Re: 11 Park Street, LLC
9&11 Park Street

We are writing on behalf of 11 Park Street, LLC to request Final Approval for the above referenced project. We have reviewed the Comments presented by Donald L. Hamlin Consulting Engineers, Inc. dated June 3, 2019, and offer the following responses;

Figure 1 - Directional Patterns of 11 Park St New PM Peak Hour Trips

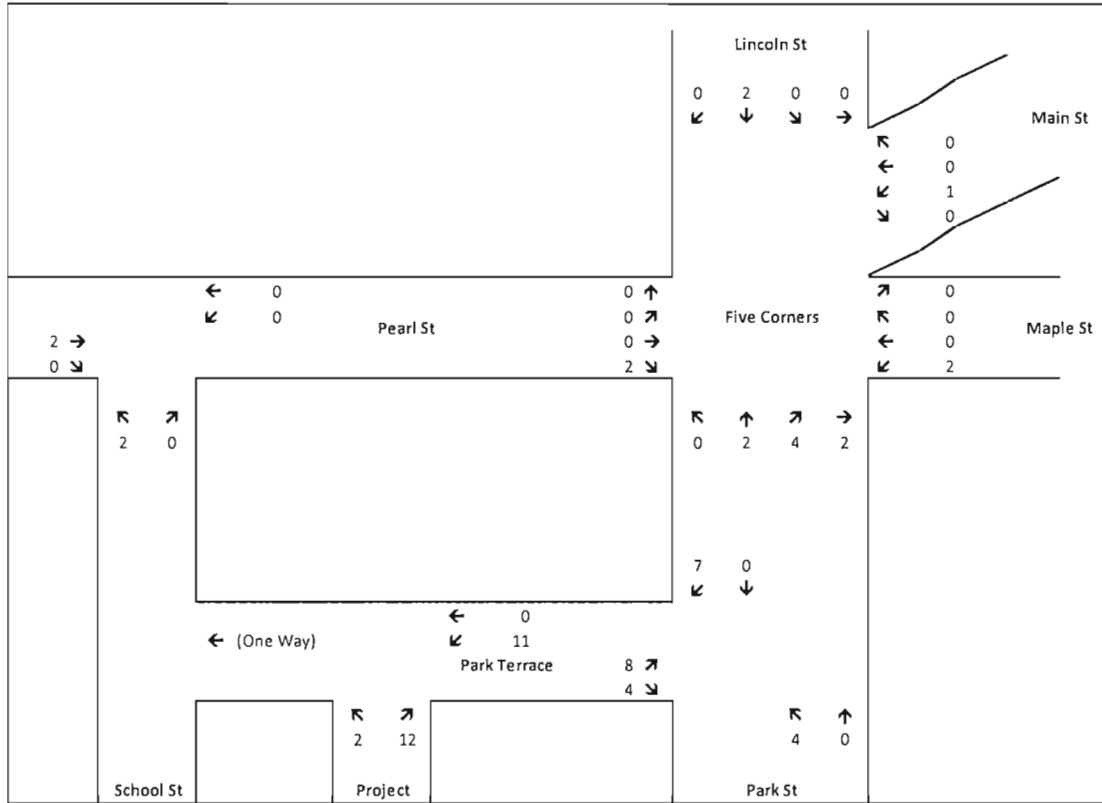
Comparing the total pm peak hour trip ends in Tables 1 and 2, this Project will generate a net increase of 25 pm peak hour trips. Figure 1 presents the projected directional patterns of those additional trips.
